HISTORIC AND DESIGN REVIEW COMMISSION

HDRC CASE NO: 2021-324
ADDRESS: 909 N HACKBERRY ST
LEGAL DESCRIPTION: NCB 529 BLK 2 LOT N 92.5 FT OF 13 & 14
ZONING: IDZ-1, H
CITY COUNCIL DIST.: 2
DISTRICT: Dignowity Hill Historic District
APPLICANT: Michael Garansuay/GARANSUAY MICHAEL S & TERESA P
OWNER: Michael Garansuay/GARANSUAY MICHAEL S & TERESA P
TYPE OF WORK: New construction of two, 2-story residential structures and two, 1-story residential structures
APPLICATION RECEIVED: June 30, 2021
60-DAY REVIEW: Not applicable due to City Council Emergency Orders
CASE MANAGER: Edward Hall
REQUEST:

The applicant is requesting a Certificate of Appropriateness for approval to construct two, 2-story residential structures and two, 1-story residential structures on the vacant lot at 909 N Hackberry, located within the Dignowity Hill Historic District.

ARCHITECTURAL SITE
PLAN

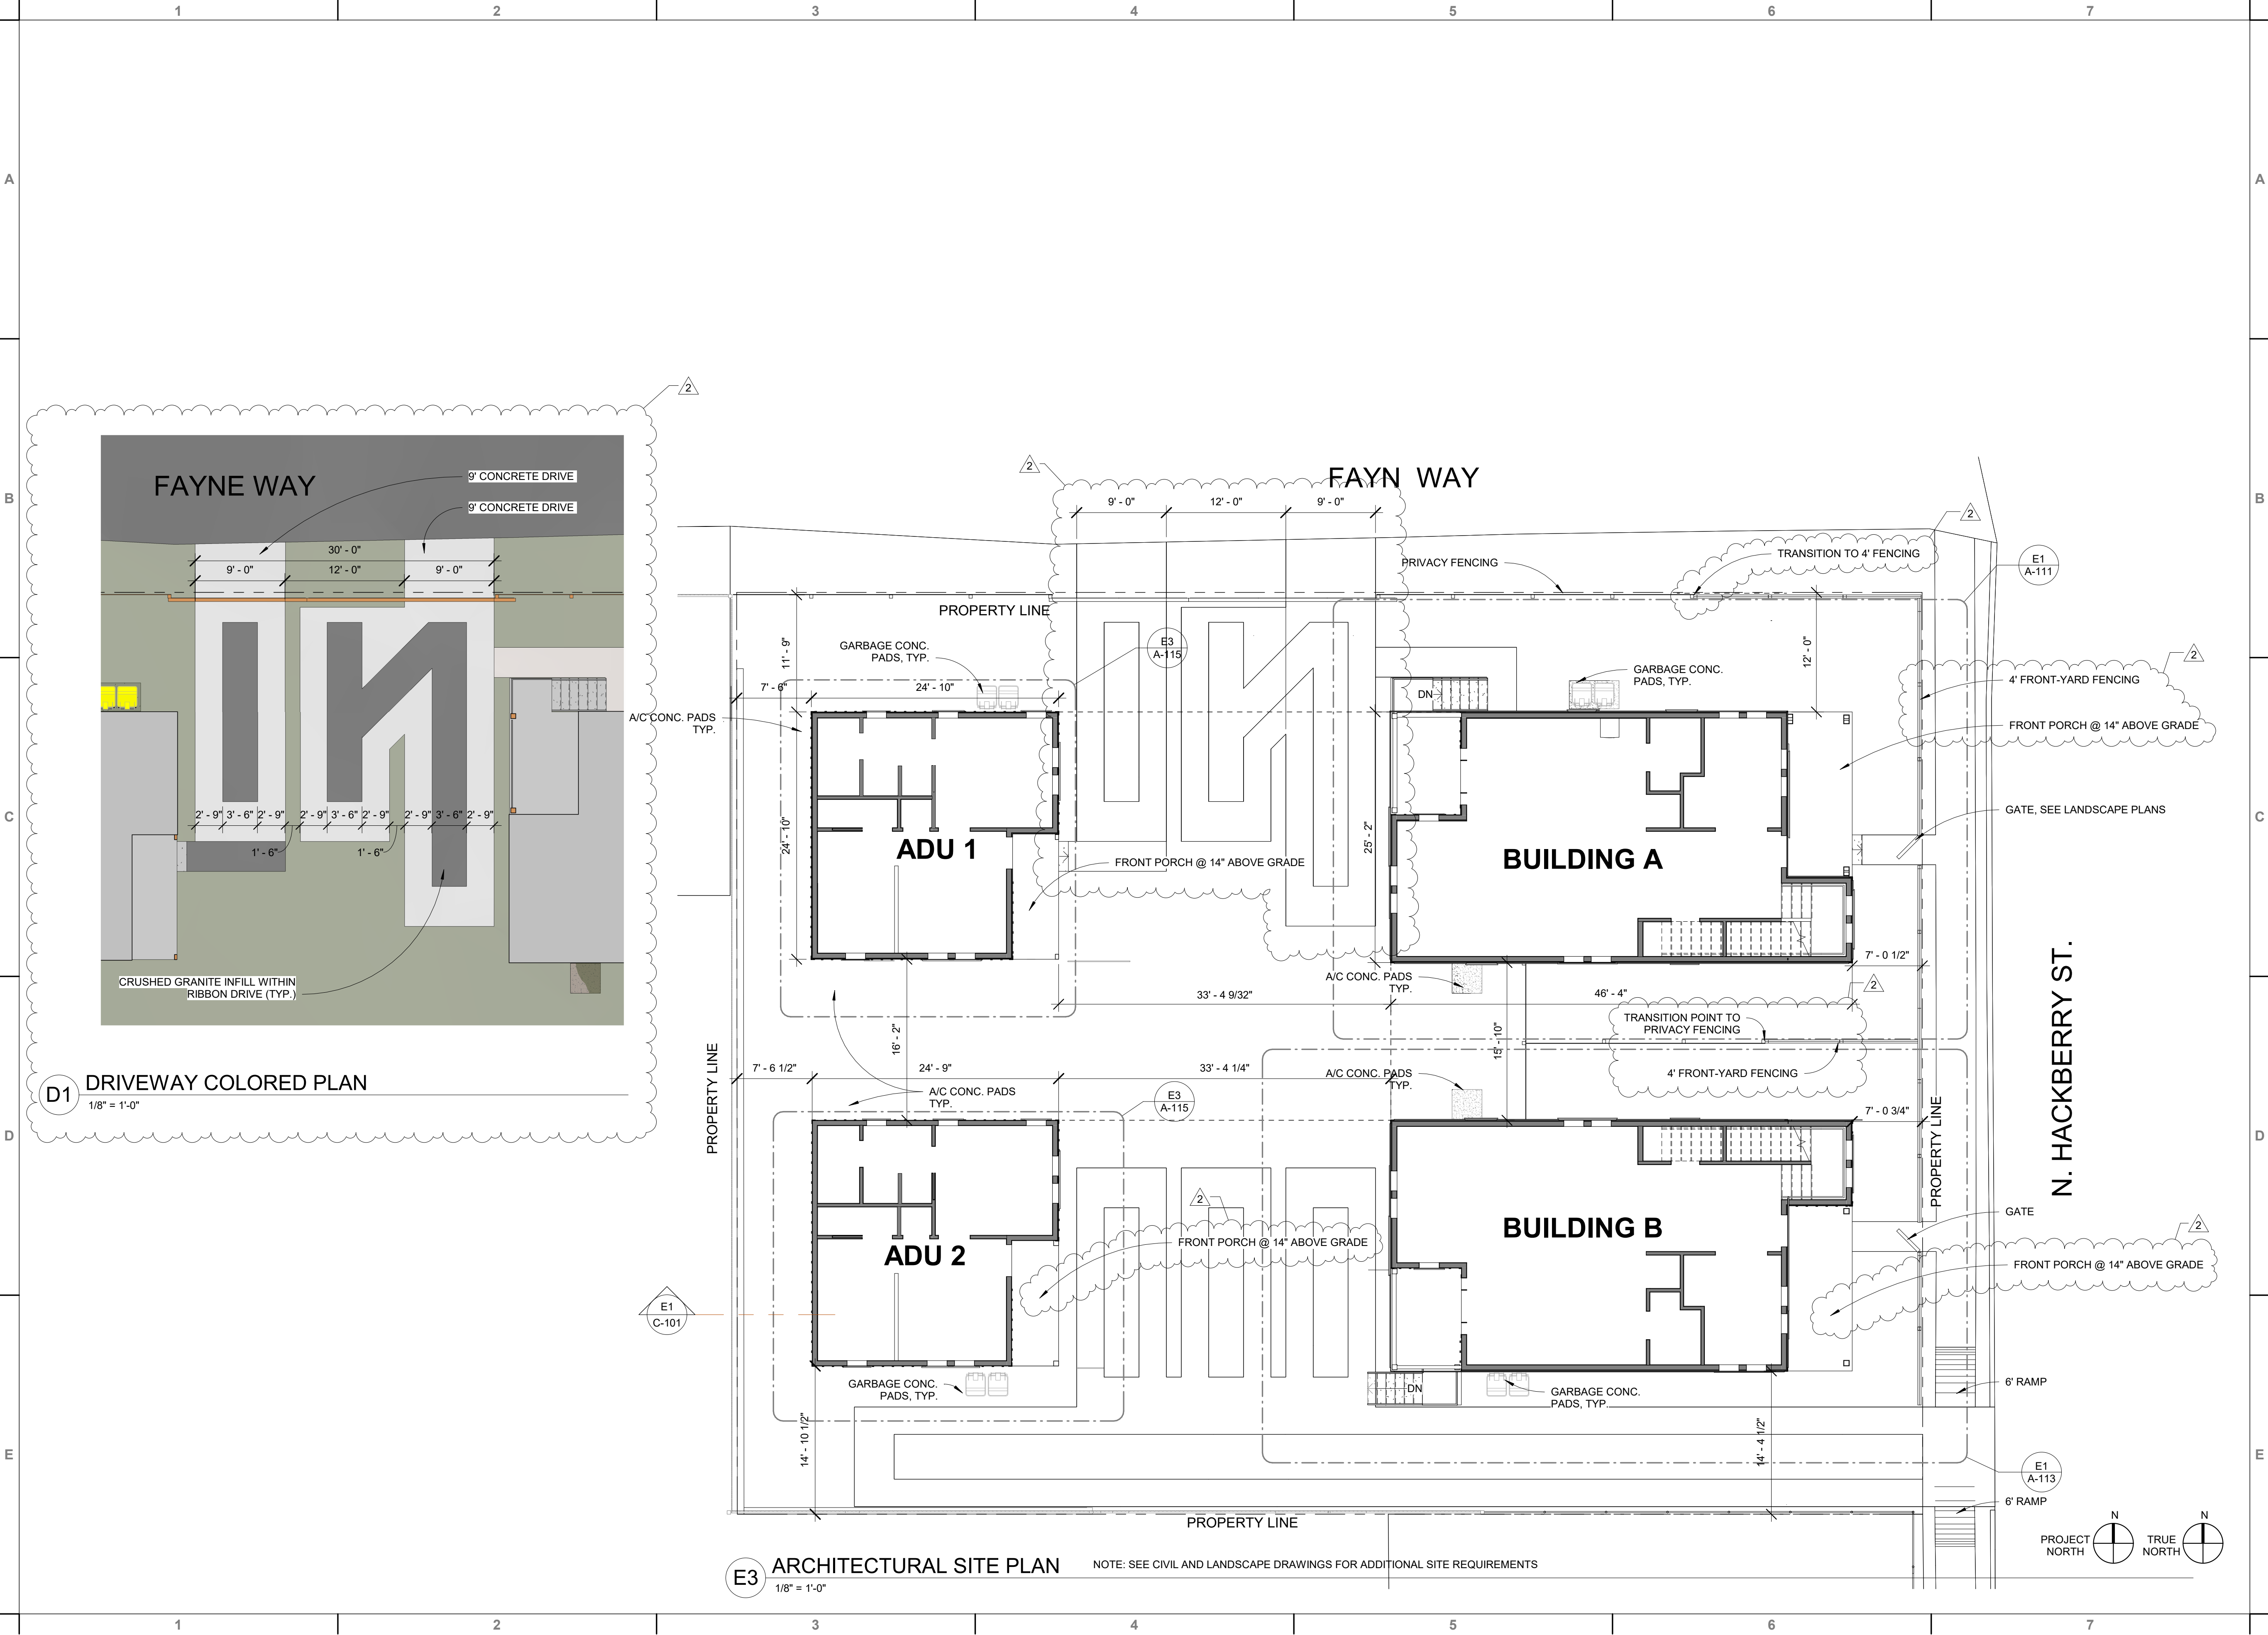
- i. That the setbacks of both primary structures on N Hackberry be increased to be greater than the setback on N Hackberry of the structure at 527 Hays, as noted in finding g.
- ii. That the applicant explore or utilize a lower floor to ceiling plate height to reduce the overall massing.
- iii. That the applicant explore the relationship of solids to voids in regards to window opening sizes and fenestration patterns. As noted in findings l and bb, staff recommends that additional fenestration should be added to facades

Response: A-050 “setback Comparison” has been produced in response to this comment to demonstrate the setback proposed for 909 N Hackberry. The structures at N. Hackberry are 9’ proud of the structure at 527 Hays. This is due to efforts to provide sufficient parking on site with necessary clearances for structures and trees. We are requesting approval of the setbacks for 909 Hackberry as shown.
